# Logan-Union-Champaign regional planning commission

## STAFF REPORT

### JEROME VILLAGE GPN - 2 (GLACIER PARK NEIGHBORHOOD SECTION 2) AMENDED PRELIMINARY PLAT

**REQUEST:** Approval of the Jerome Village Glacier Park Neighborhood Section 2  
AMENDED Preliminary Plat in Jerome Township, Union County

DETAILED COMPOSITE UTILITY PLAN

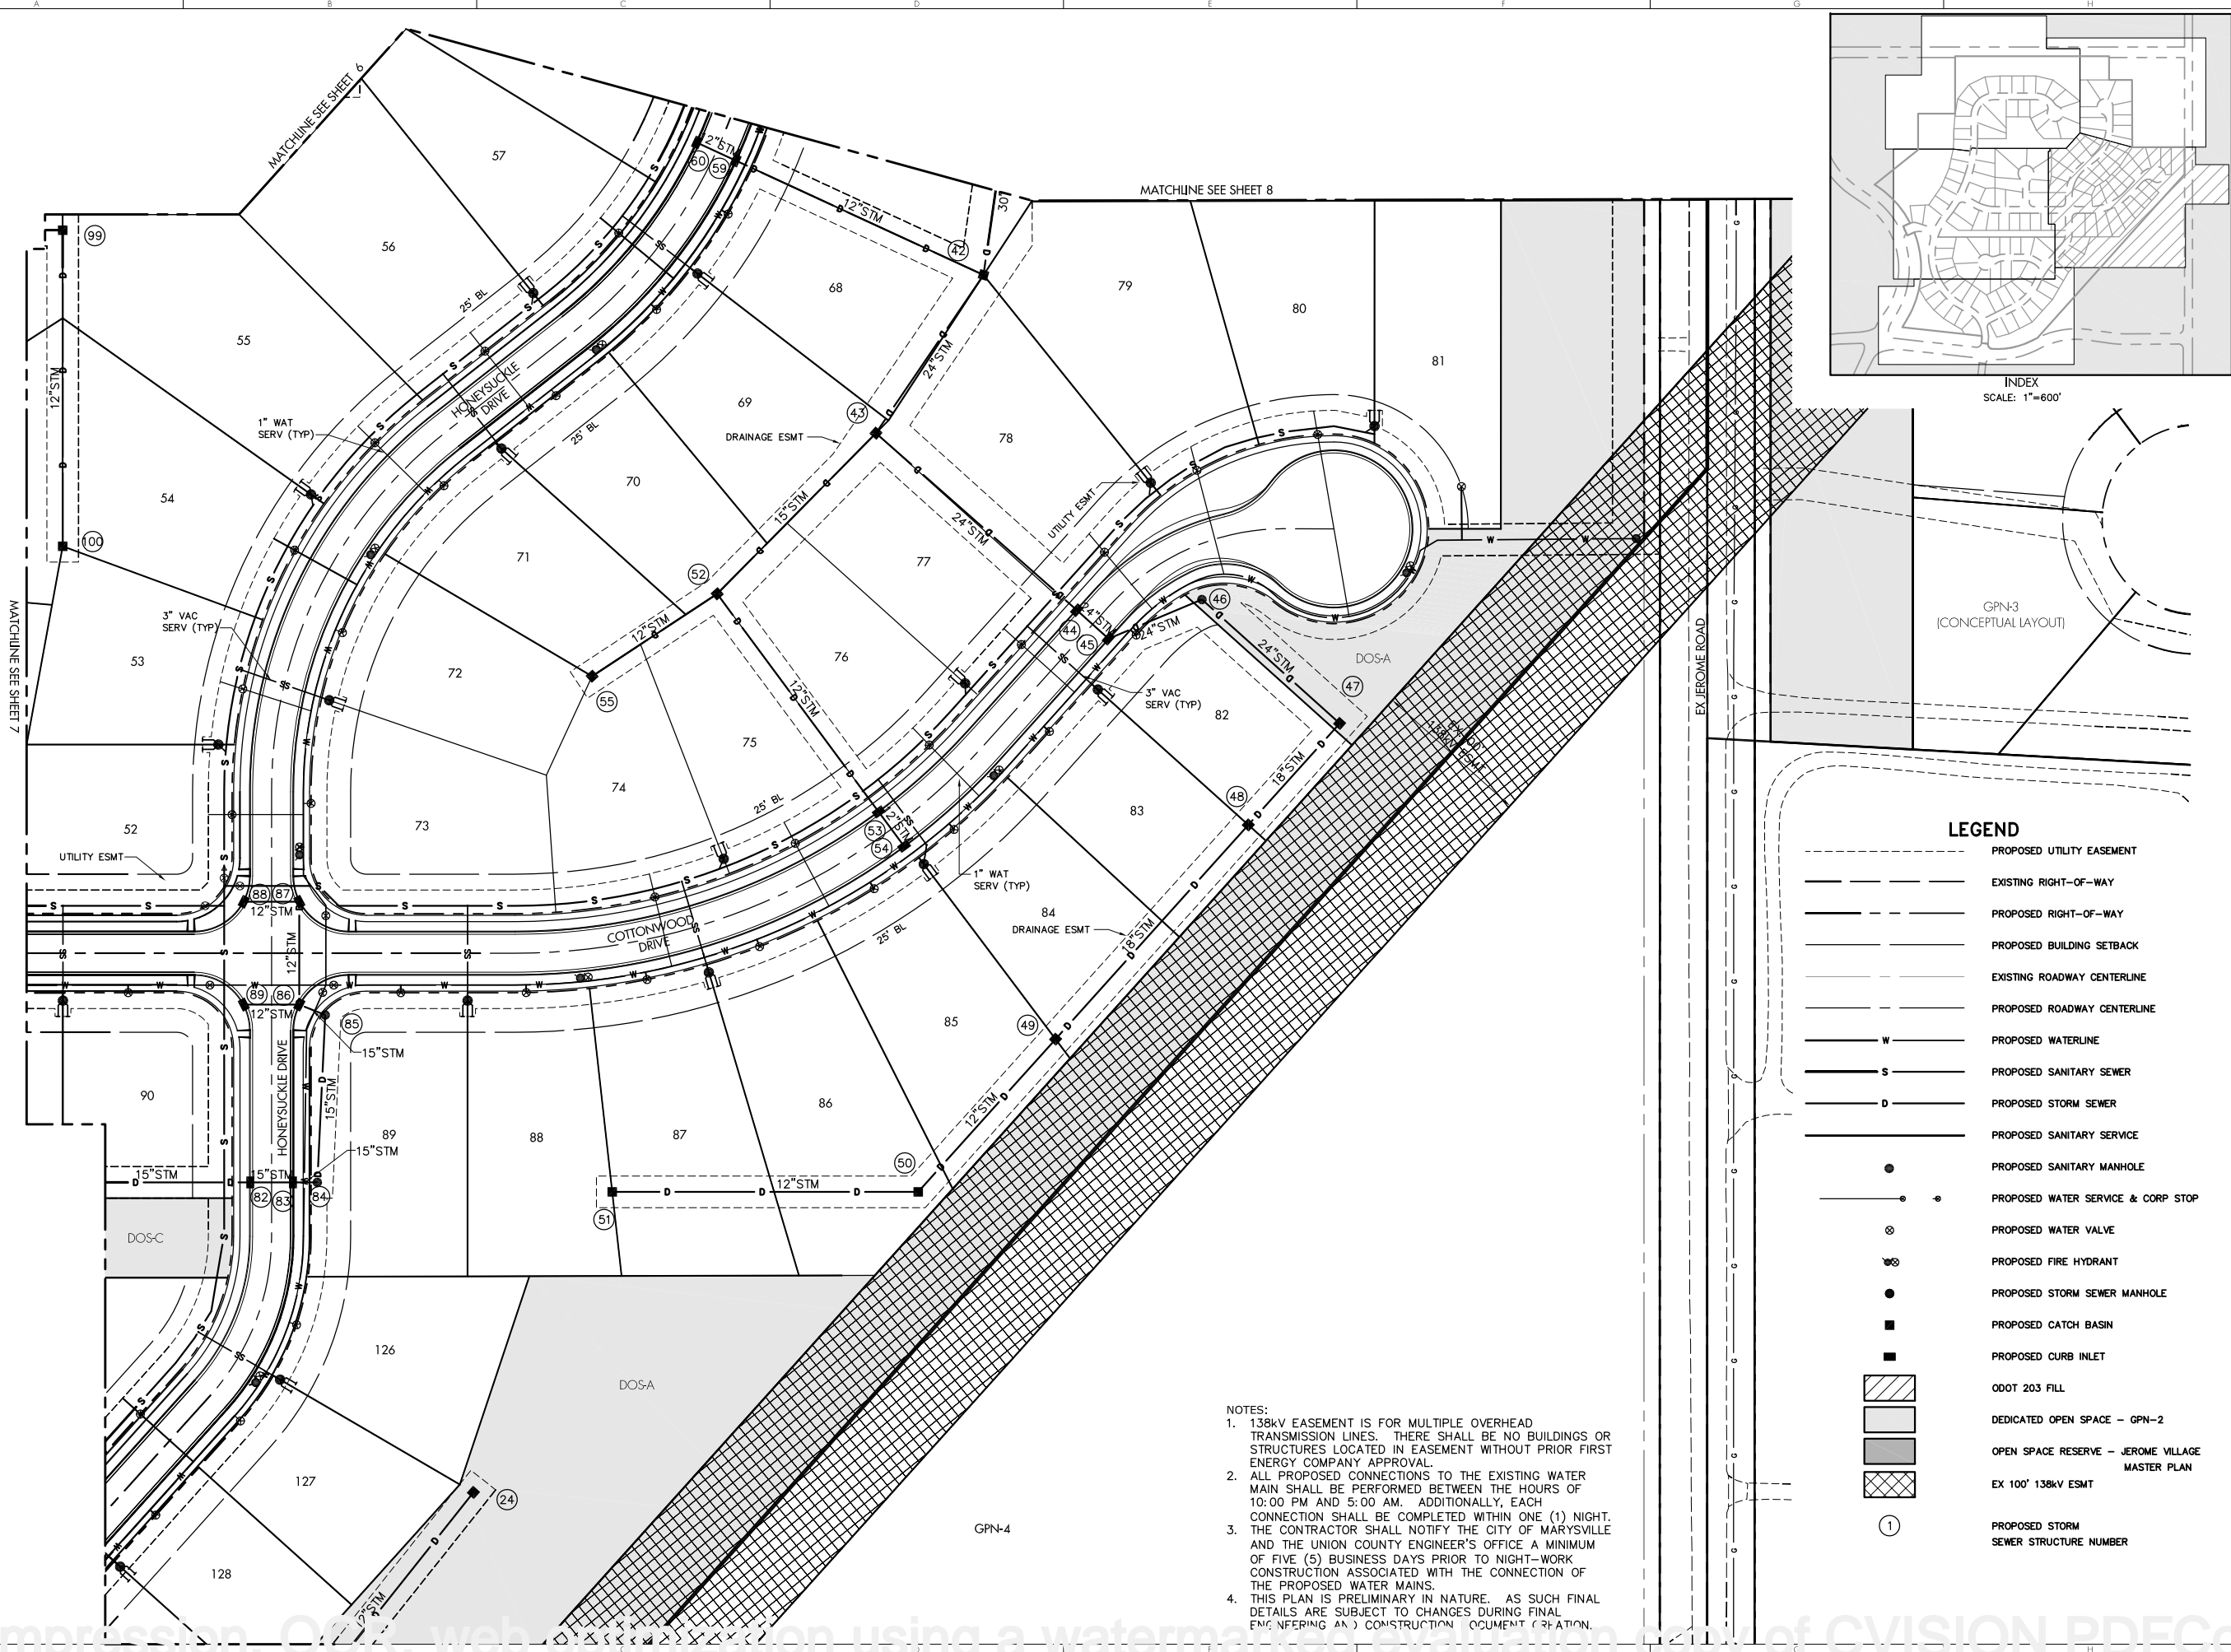
- ✓ Preliminary Plat (Sheet 4) – Provide labels on the existing easements along Ryan Parkway.
  - ✓ Detailed Composite Utility Plan (Sheet 7)
    - Several waterline appurtenances are "connected" to the right-of-way (near the Spruce Court Honeysuckle Way intersection and along Brandywine Drive). Please revise accordingly.

1. Several waterline appurtenances are “connected” to the right-of-way (near the Spruce Court Honeyuckle Way intersection and along Brandwyne Drive). Please revise accordingly.
2. The northernmost valve at the Cottonwood Drive and Hawthorne Drive intersection shall be located north of Storm Structure #78 and outside the pavement.

**HAWTHORNE DRIVE**  
PRELIMINARY PLAN & PROFILE  
STA. 0+00 TO 10+00

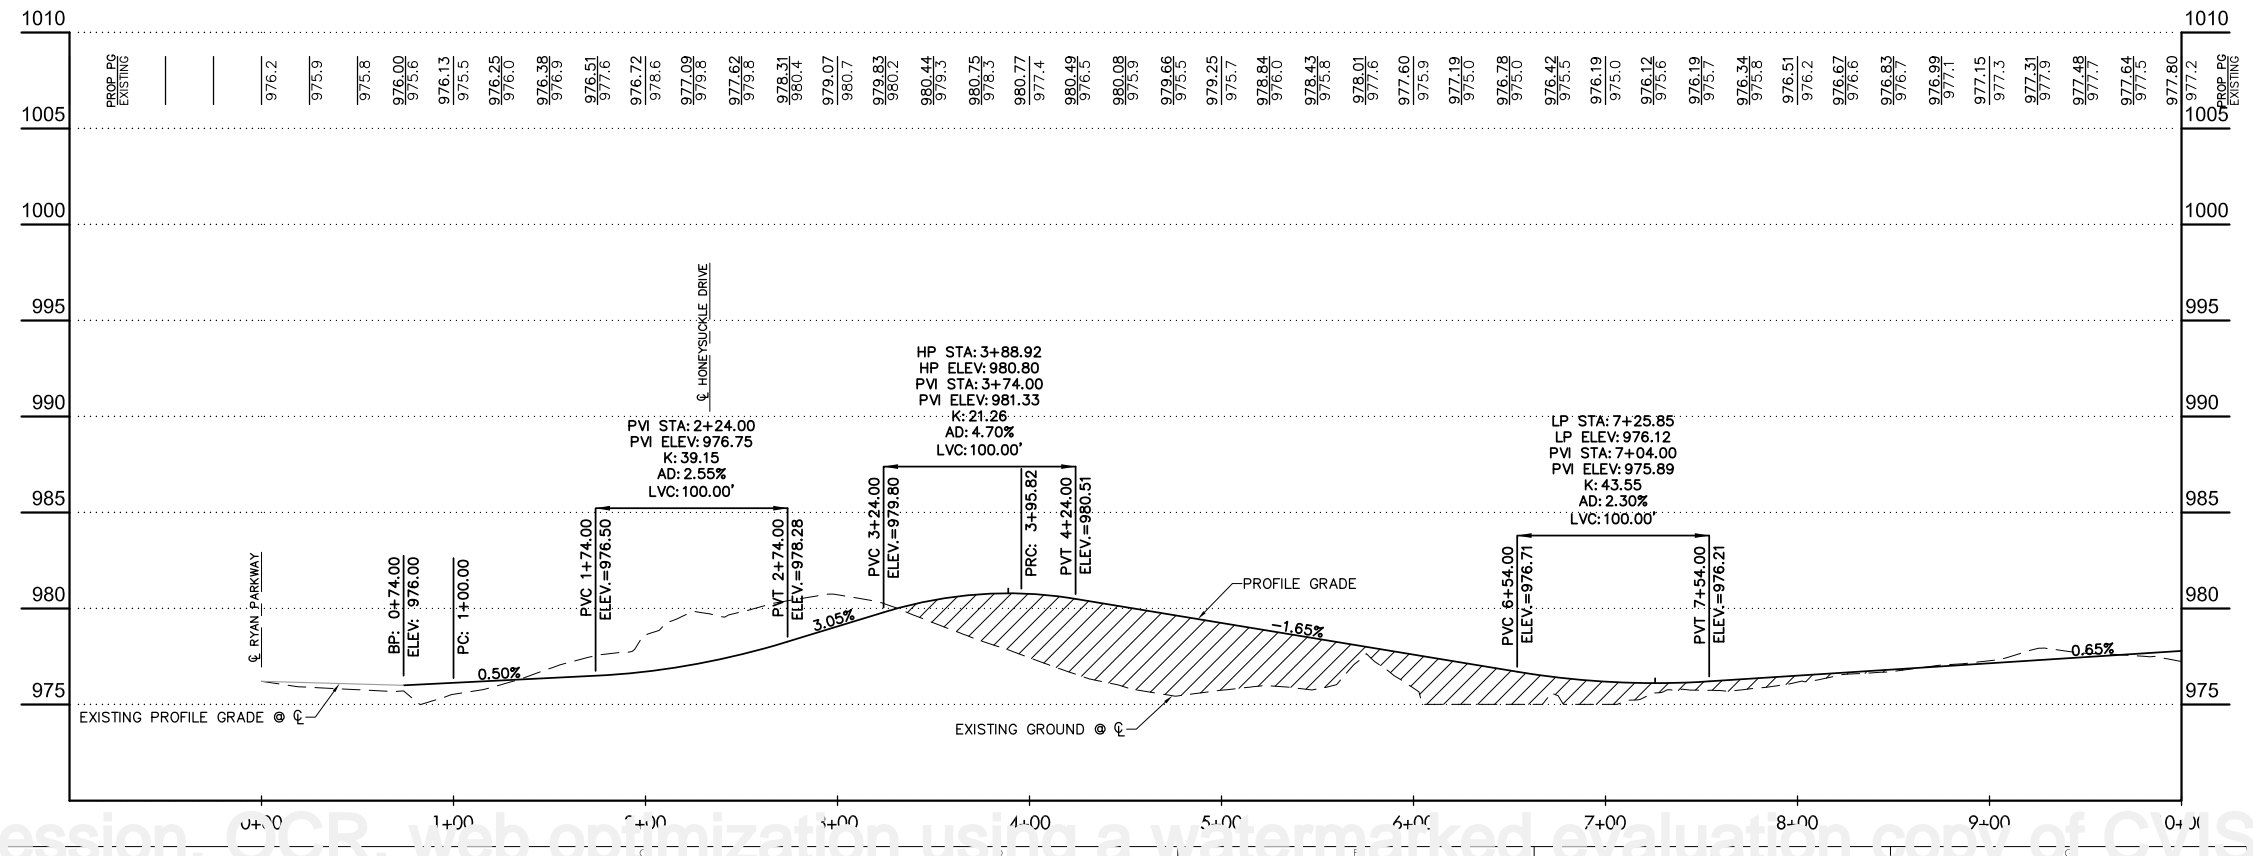
- Indicate design and posted speeds.
  - Include signage plan for roadway network.
  - With the exception of stop condition vertical curves at intersections, the minimum length of all vertical curves shall be 50'. The vertical curve at Station 11+54 on Hawthorne Drive does not meet this requirement. Based on ODOT Standards, this

- vertical curve can be completely removed, as it does not meet the minimum grade change required.
- Update flood routing plan to show routing break points on roadways.
